Sullivan's Ledge
5.4.1
8464

EXPLANATION OF SIGNIFICANT DIFFERENCES

Site: Sullivan's Ledge Superfund Site --
Operable Unit I ("OU-I")

Site Location: New Bedford, Massachusetts

Figure 1: Floodplain Section

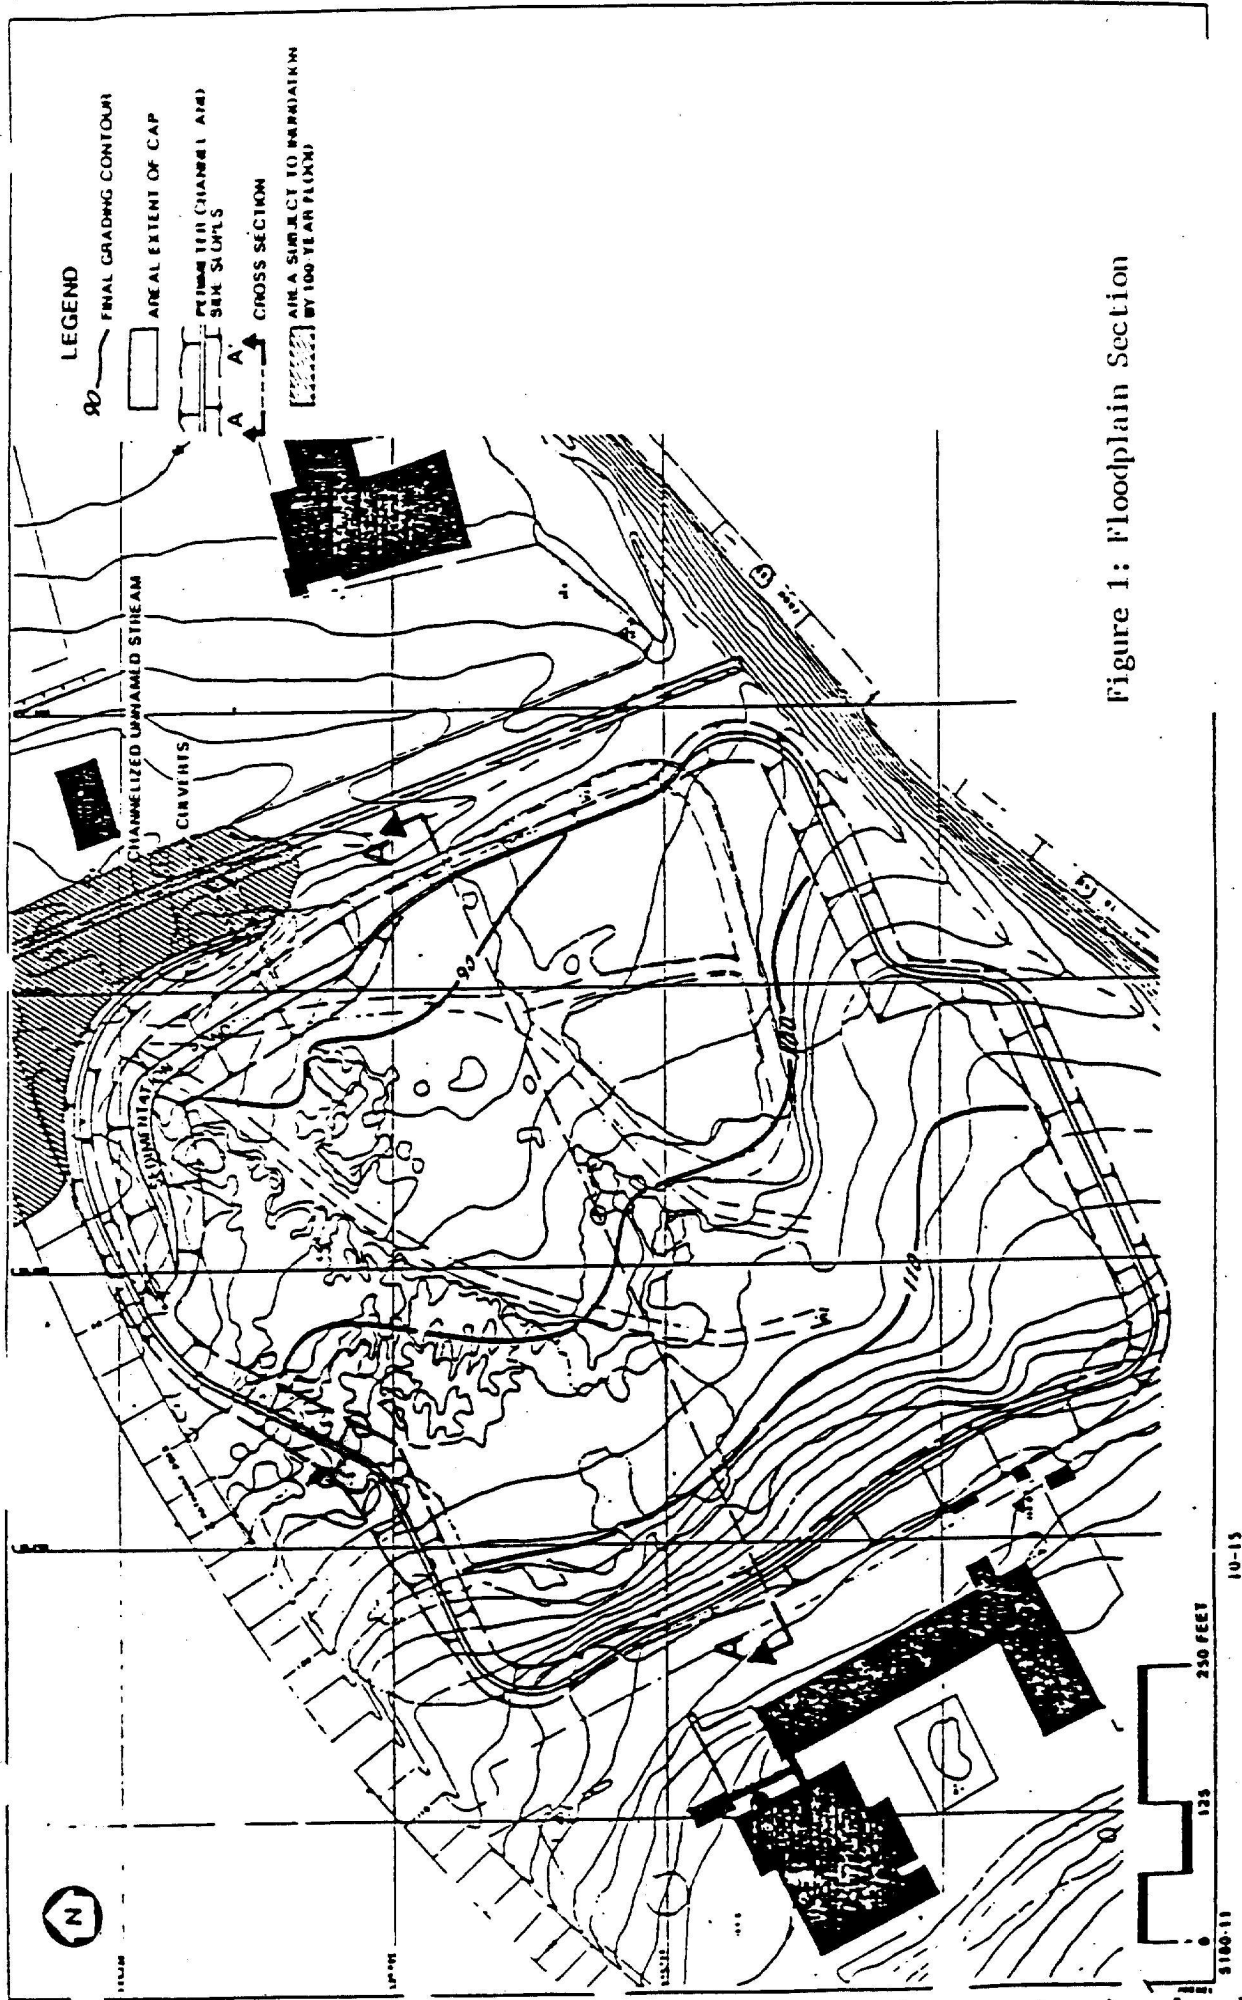
Under the revised remedy, soil in the Disposal Area outside of the floodplain section will not be excavated and, therefore, will remain untreated. That soil will remain in place and be covered by the cap. Consistent with the OU-I ROD, the cap will be constructed over the entire surface area of the Disposal Area, except for the floodplain section. Also consistent with the OU-I ROD, Disposal Area unsaturated soil in the floodplain that is contaminated above excavation cleanup standards (50 ppm PCBs and/or 30 ppm PAHs) will be excavated and disposed of beneath the landfill cap, outside of the floodplain. As described below, under the revised remedy, excavated soil from the floodplain shall also remain untreated.

In addition, as explained in this ESD, off-site soil and stream sediments that exceed solidification cleanup standards (soil - 50 ppm PCBs; sediments - 20 micrograms per gram of carbon) will not be treated. Instead, off-site soil and sediments that exceed excavation criteria (soil - 10 ppm PCBs; sediments - 20 micrograms per gram of carbon) shall be excavated and disposed of beneath the landfill cap, outside of the floodplain.
